STAFF COMMENTS

PLANNING BOARD MEETING

Case #06-16: SITE PLAN REVIEW

North Coast Seafood Processing Plant Expansion
43 Blackmer Street
Map 25A, Lots 1, 3 & 52

Site Plan (SP) – Sheet 3/6

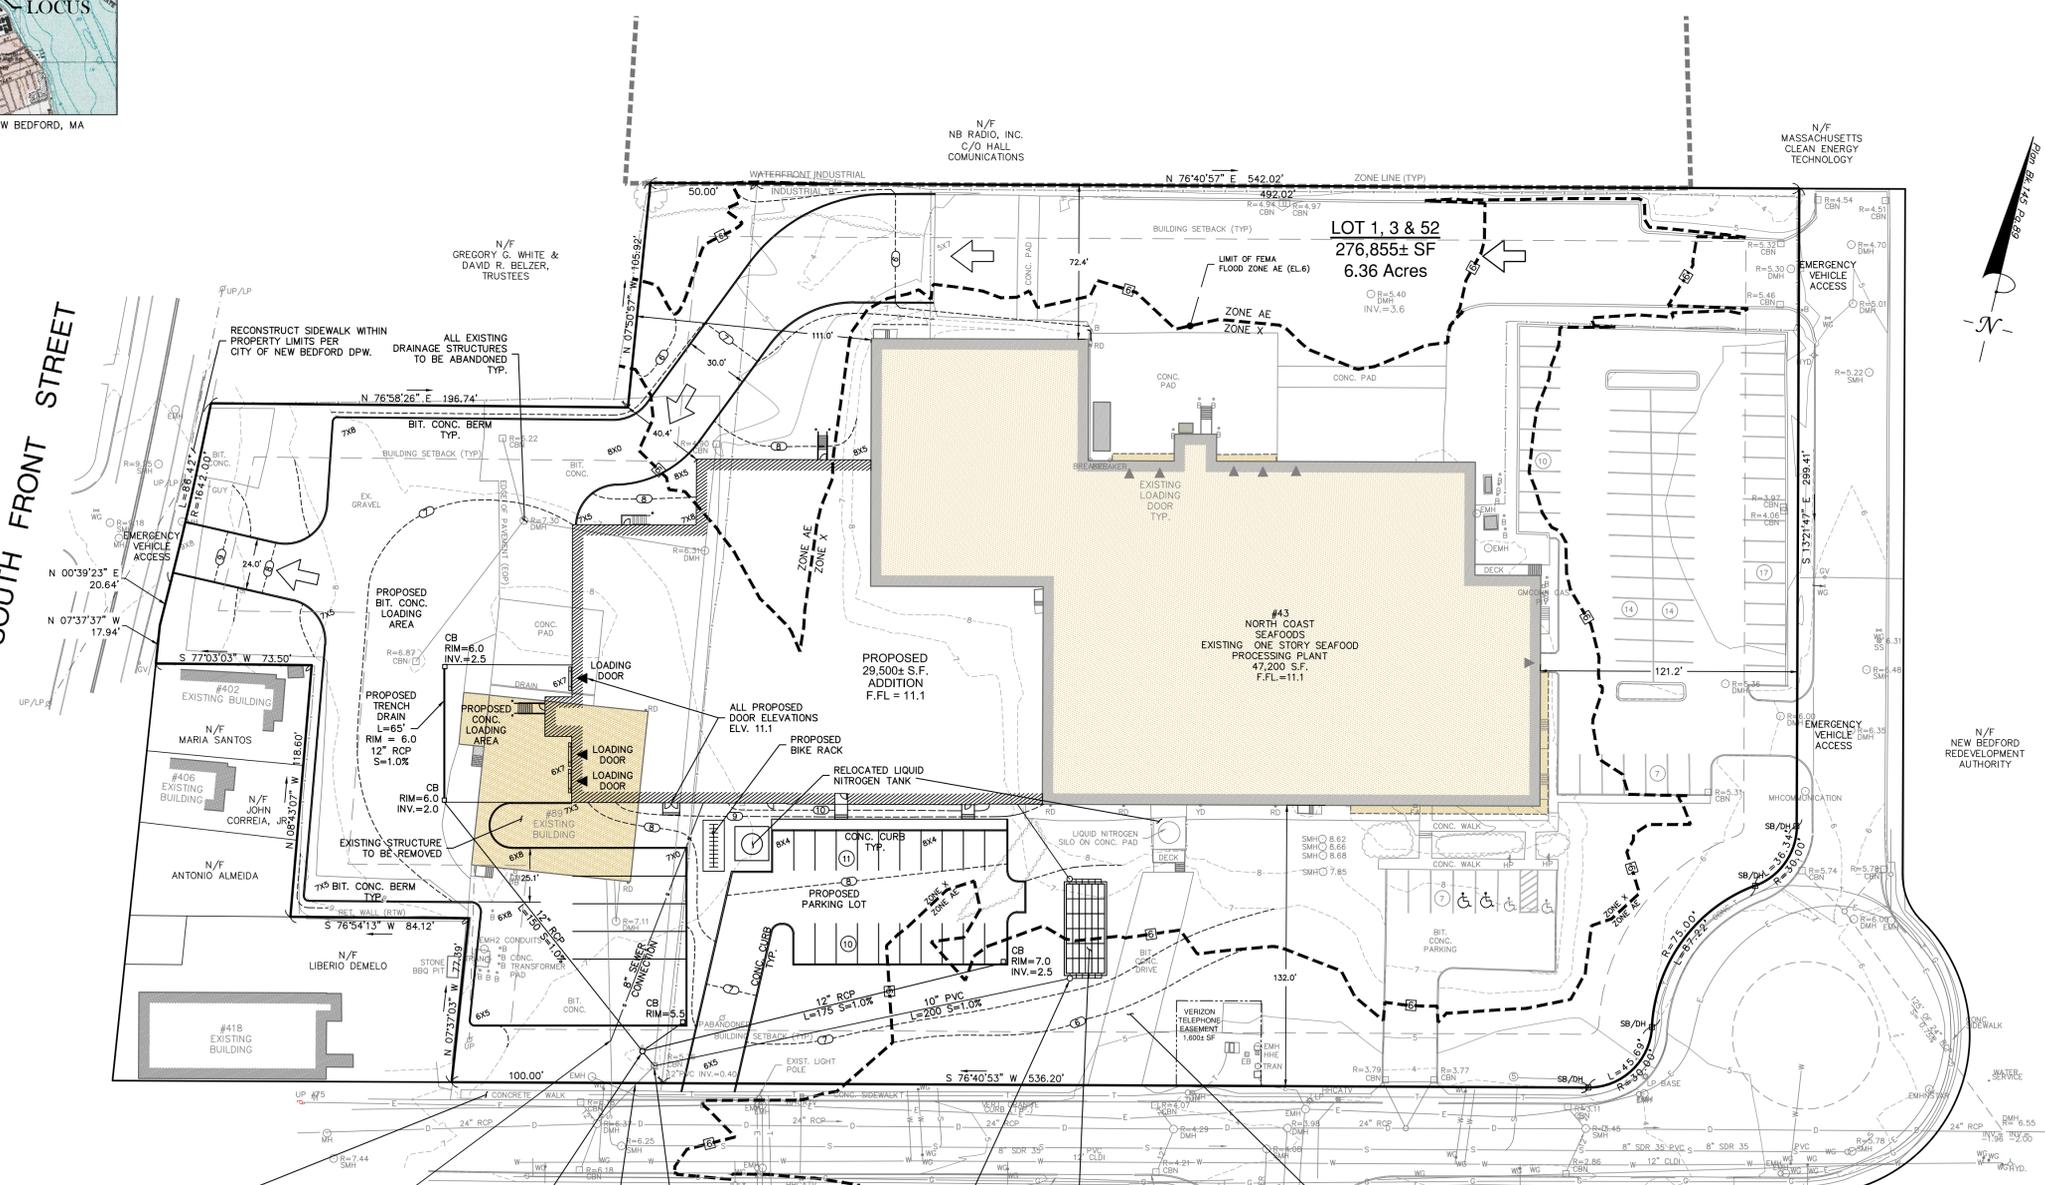
In addition to a modified circulation pattern, the number of loading bays will increase from seven (7) to ten (10). [NOTE: The proposed site plan identifies nine (9) loading bays; it will be helpful for the Planning Board to see the location of the tenth loading bay identified on plans.]

Elevation drawings and site plan bear inconsistencies regarding relocation of nitrogen tank, location of loading bays, and number and location of ingress and egress.

- The Site Plan should be revised and submitted to planning staff and include all lighting types/locations, notes regarding curb and pavement types, lighting location and specifications, dumpster location/s and screening materials, identification of ten (10) loading bays, and snow storage area/s.

HAYBALE EROSION CHECK
NOT TO SCALE

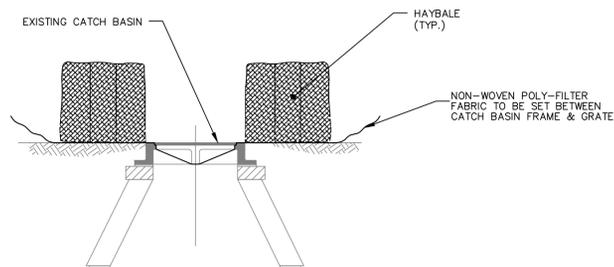
10. Site Stabilization. This revision specifying straw rather than hay should also be noted on Detail sheet DTI and Landscape Plan sheet LS.

at paragraph 1. Installation of Erosion Controls and paragraph 10. Site Stabilization. This revision specifying straw rather than hay should also be noted on Detail sheet DTI and Landscape Plan sheet LS.

- As the Planning Board's standard of practice recommends erosion control measures to utilize straw rather than hay bales, staff asks the applicant revise Hay to Straw bales under the Operation and Maintenance Plan

DRAWING NO.
A3.1
 15-090

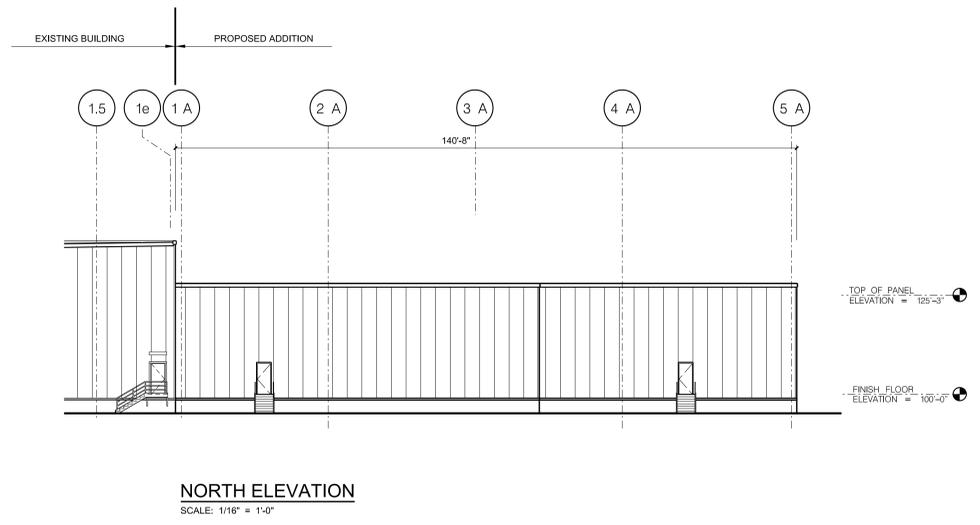
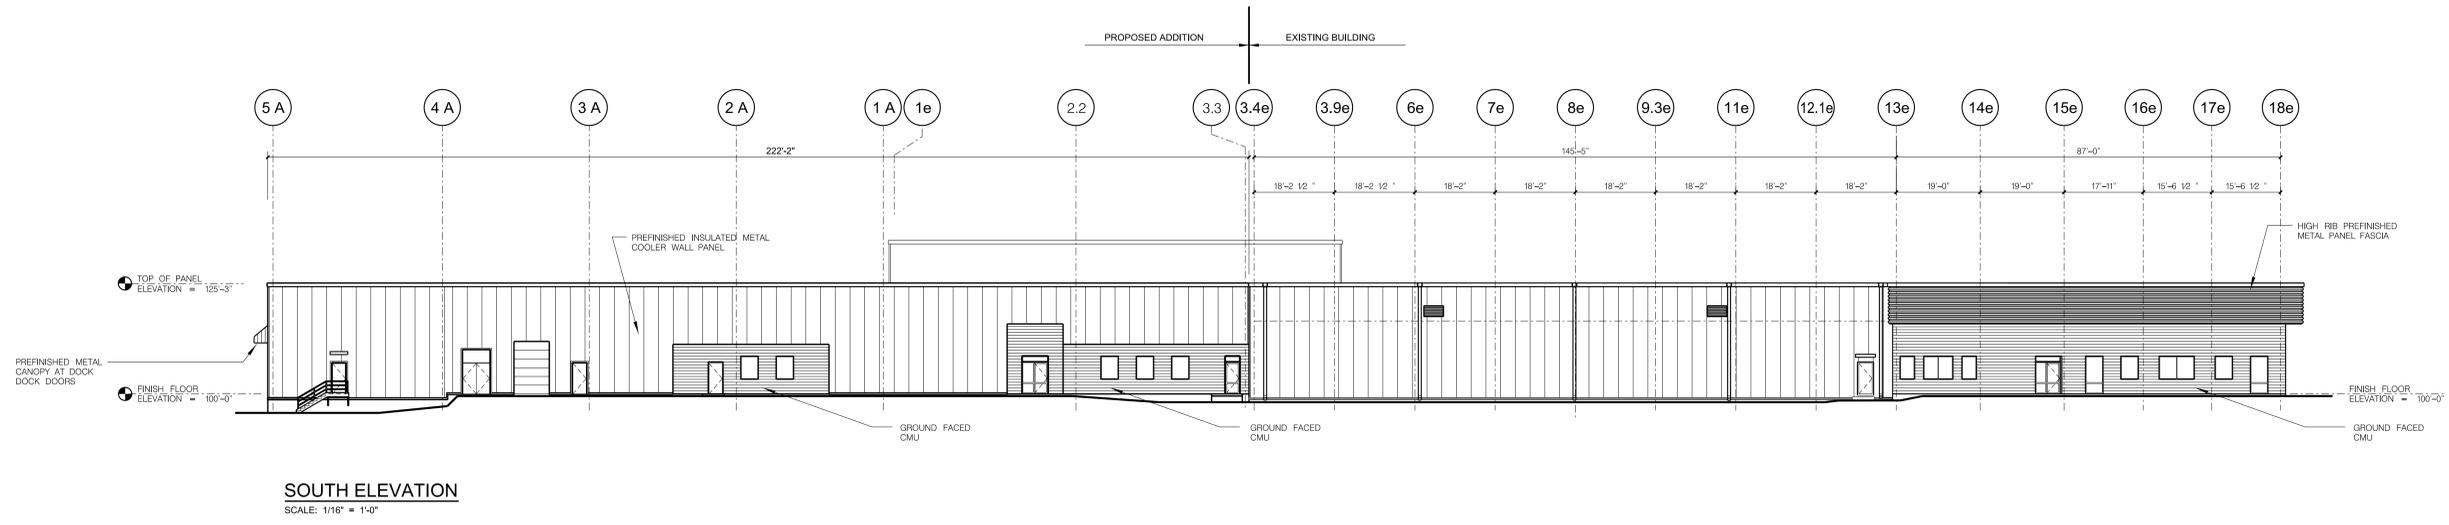
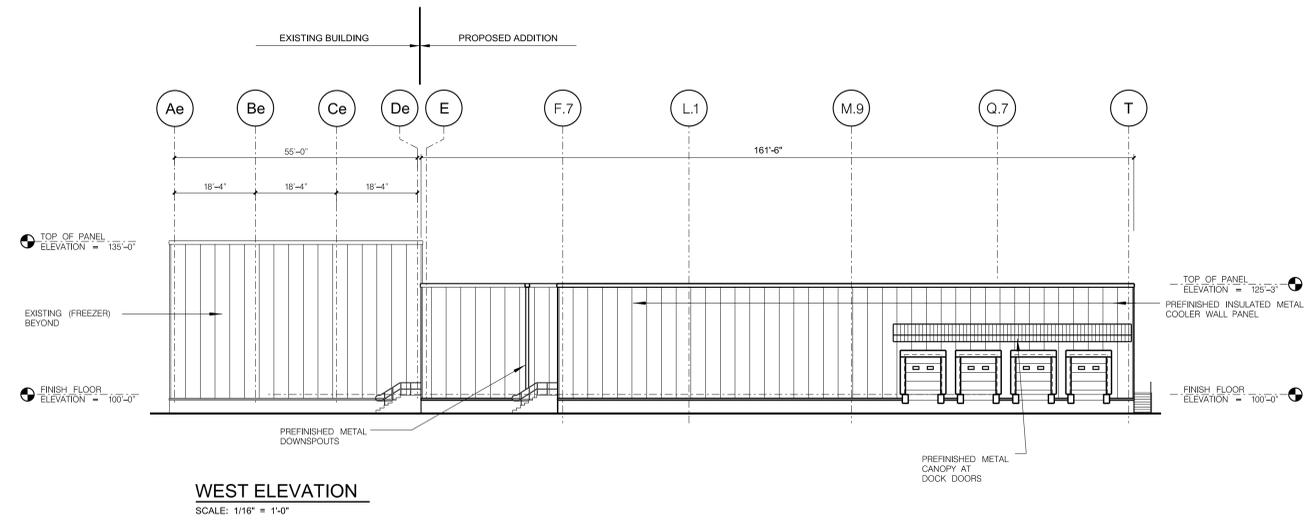
- Building Elevation plans to identify all proposed exterior materials -including roofing, finish color of materials, and treatment at the loading docks, and all building entrances and comply with the covenants under deed restriction.
